# Access Compliance Report

## Public Rights-of-Way

### (Curb Ramps)

Intersection ID: 42363	Main Street: CONDOR_CR	Cross Street: KESTRAL_RIDGE_DR	Location: SW
ADA ID: 040600C726F0	Ramp Type: BlendTrans1	Initial Pass/Fail: Pass	Overall Compliance: No
		Severity Score: 10

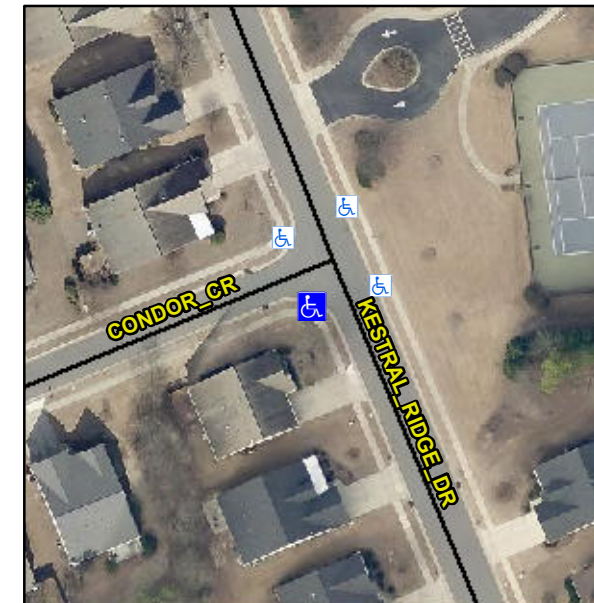
**Not Found, R304.2.2-Perp, R304.3.2-Para, R304.5.3, R305**

N/A	Ramp inside XWalk1?	N/A	N/A	Ramp inside XWalk2?	N/A
	Road Slope (%)	2.1		Clear Space?	Yes
	Road X Slope (%)	1.7	N/A	Clear Space to XWalk (in)	N/A
Yes	Any Obstructions?	No	Yes	Storm Grate/Utility Hazard?	No
	Obstruction Type			Storm Grate/Utility Type	
		N/A			N/A
			Yes	Surface Condition? (G/P)	Good
			No	Curb Slope (%)	24.8

**Remove & Replace Curb Ramp With Two New Directional Ramps or Equivalent.**
